UNITED STATES PATENT AND TRADEMARK OFFICE

APPLICATION NO.	FILING DATE	FIRST NAMED INVENTOR	ATTORNEY DOCKET NO.	CONFIRMATION NO.
10/579,770	03/12/2007	Viggo Aaberg Kaern	2003039-US	5690
69289	7590	02/08/2010		
COLOPLAST A/S Attention: Corporate Patents Holtedam 1 DK-3050 Humleback, DENMARK			EXAMINER TREYGER, ILYA Y	
			ART UNIT 3761	PAPER NUMBER
			NOTIFICATION DATE 02/08/2010	DELIVERY MODE ELECTRONIC

Office Action Summary	Application No. 10/579,770	Applicant(s) KAERN ET AL.	
	Examiner ILYA Y. TREYGER	Art Unit 3761

DETAILED ACTION

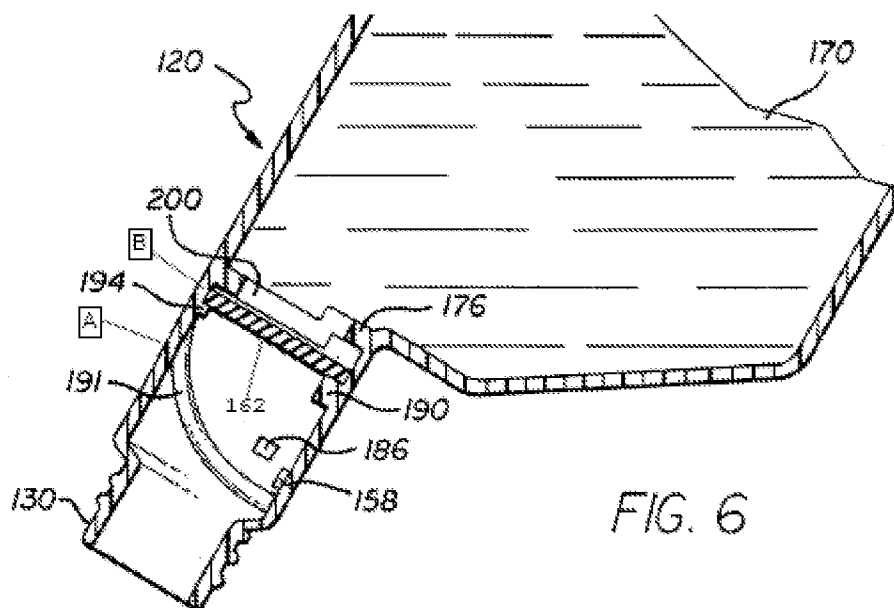
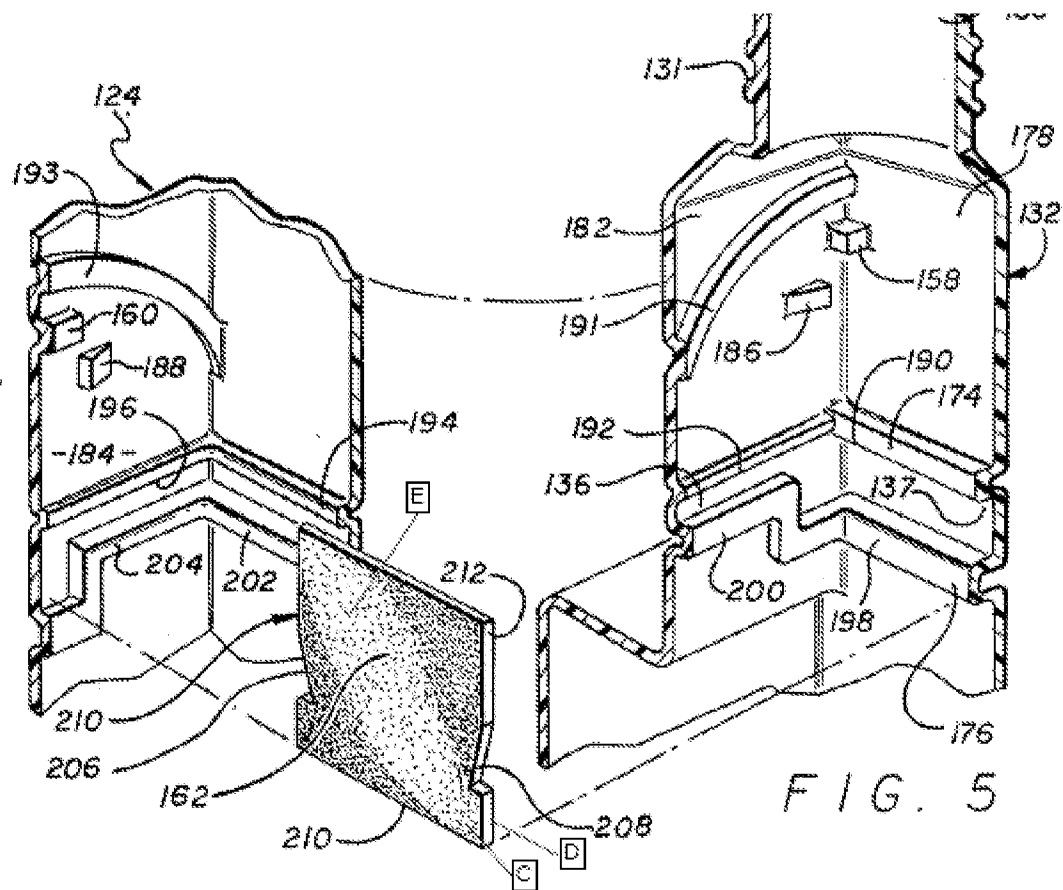
10. In Re claim 1, Jangaard discloses a neck of a bottle that is an anti-reflux device comprising:

a wall A (Fig. 6) providing a valve seat B (Fig. 6), and a valve element 162 (Figs. 5 and 6) defining an outer contour 212 (Fig. 5) formed from a sheet-shaped material, said valve element including a connecting portion C (Fig. 5) and a flap portion E (Fig. 5) defining a longitudinal direction extending between the connecting portion and the flap portion, and retaining means 190 (Fig. 6) fully capable of retaining the valve element 162 with respect to the device, said retaining means being integral with the device. The connecting portion C (Fig. 5) includes the engagement means D (Fig. 5) formed integrally with the valve element for engagement with the retaining means, wherein the valve element projecting a coherent plane (See Col. 8, lines 9-21 and 32-46; Figs. 5 and 6).

12. In Re claims 6, 7, and 9, Jangaard discloses a device in which said outer contour A forms a curve defining a continuously advancing function on a respective side of the longitudinal direction (claim 6), and wherein the engagement means D are formed within (claim 7) and integrally (claim 9) in said outer contour (claim 7) (See Fig. 5).

13. In Re claim 12, Jangaard discloses the valve element including at least one connecting portion and a flap portion and defining a longitudinal direction extending between the connecting portion and the flap portion, and with engagement means integrally formed in the valve element (See Col. 8, lines 9-21 and 32-46; Figs. 5 and 6).

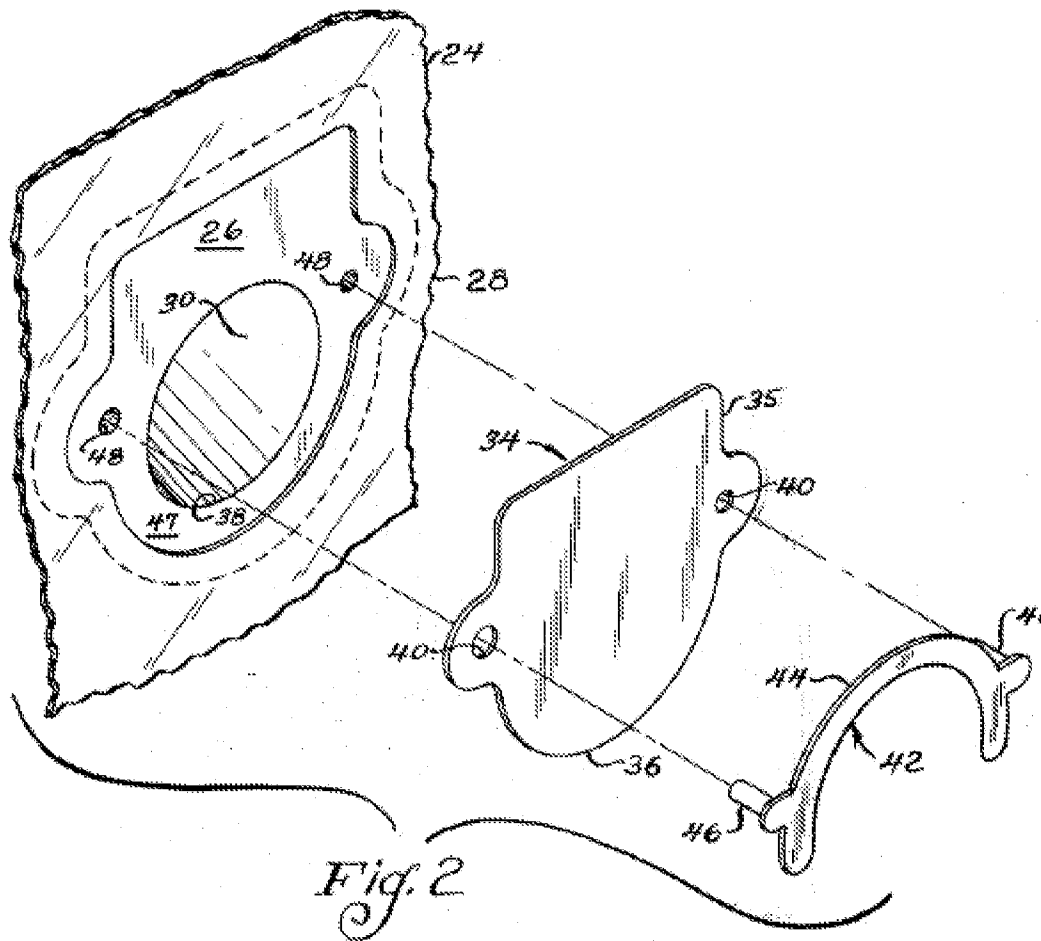
20. The following is a statement of reasons for the indication of allowable subject matter: The specific limitations of “a hook- shaped section” are not anticipated or made obvious by the prior art of record. For example, the US 3,965,900 teaches a valve element 34 (Fig. 2) defining an outer contour A (Fig. 2) formed from a sheet-shaped material, said valve element including a

connection portion B (Fig. 2) and a flap portion C (Fig. 2) defining a longitudinal direction extending between the connecting portion and the flap portion, and bores 48 (Fig. 2) which are retaining means for retaining the valve element 34 with respect to the device, said retaining means being integral with the device.

FIG.2

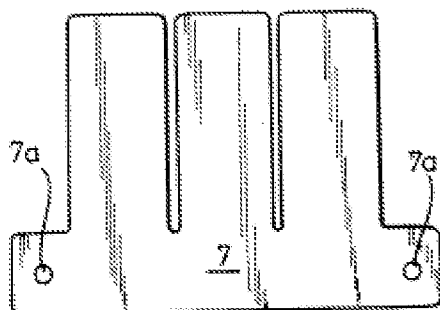
Morone teaches the flap valve wherein the valve element is slit- or incision-shaped (since the incision is a variation of slit) (See Fig. 2).

It would have been obvious to one having ordinary skill in the art at the time the invention was made to make the valve element of Jangaard slit- or incision-shaped, as taught by Morone in order to improve valve element fixation.
